Uxbridge Town Centre West

Design statement in support of Non-material Amendment Application

June 2023

Proposed Block 3 Second Floor Layout

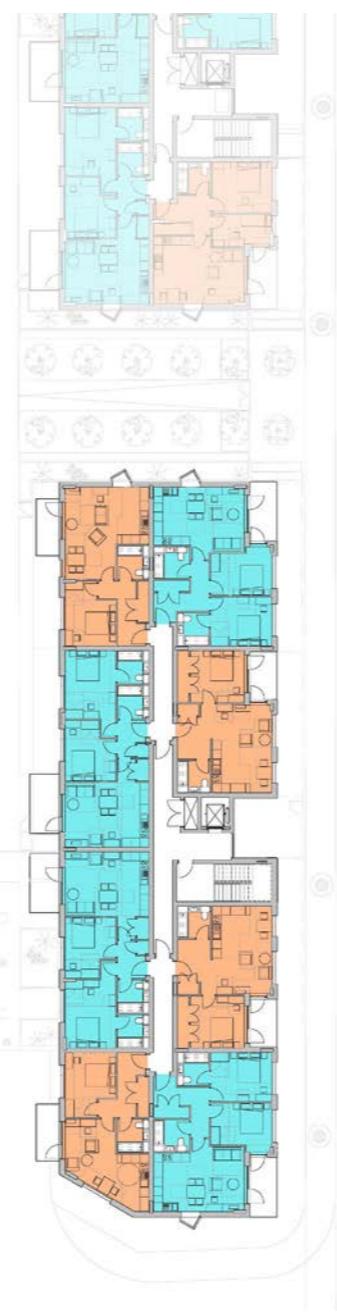
- AOVs added
- Notches in party wall at entrance omitted
- Secondary access to balconies omitted to all flats and replaced with windows

- Fire separation added to stair
- Post boxes relocated in Block 3B

Consented Block 3 Fourth to Fifth Floor Layout

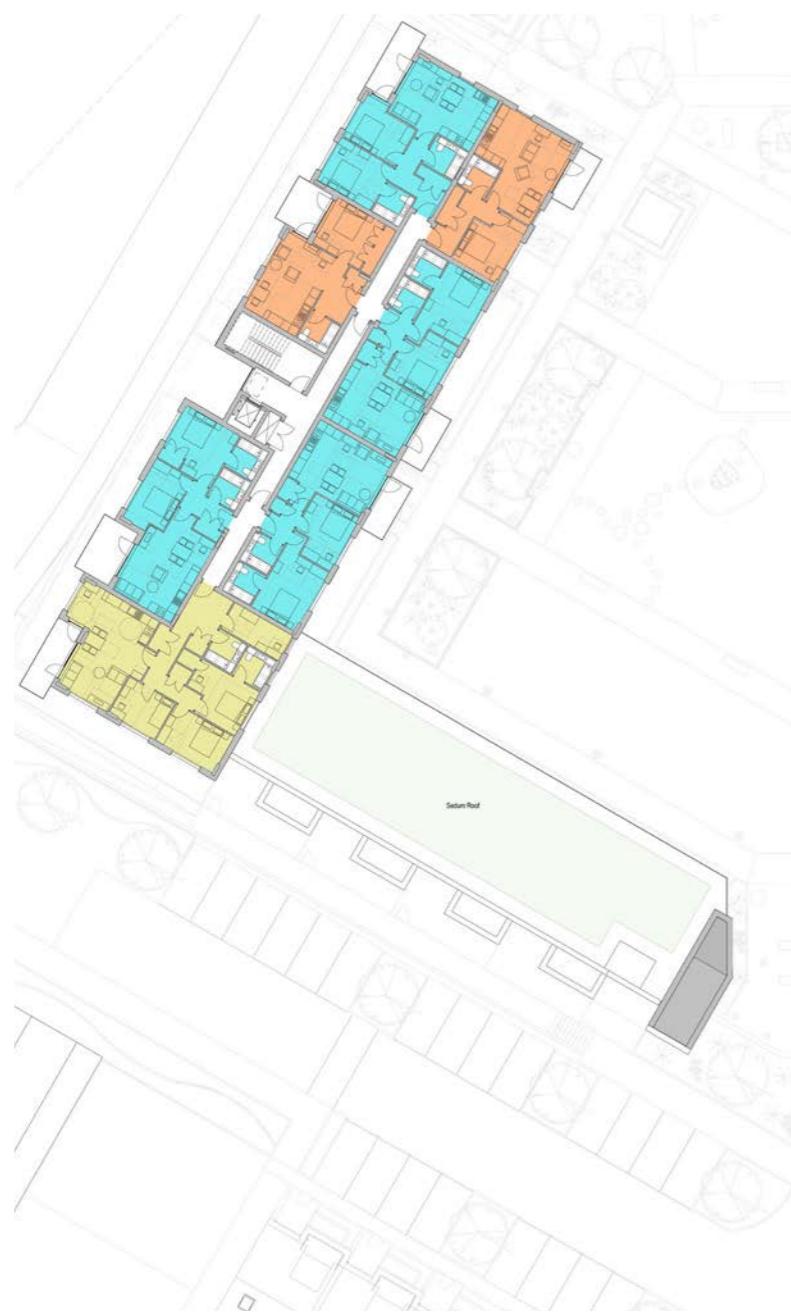
- AOVs added
- Notches in party wall at entrance omitted
- Secondary access to balconies omitted to all flats and replaced with windows

- Fire separation added to stair
- Post boxes relocated in Block 3B
- AOV opening at head of stair shown
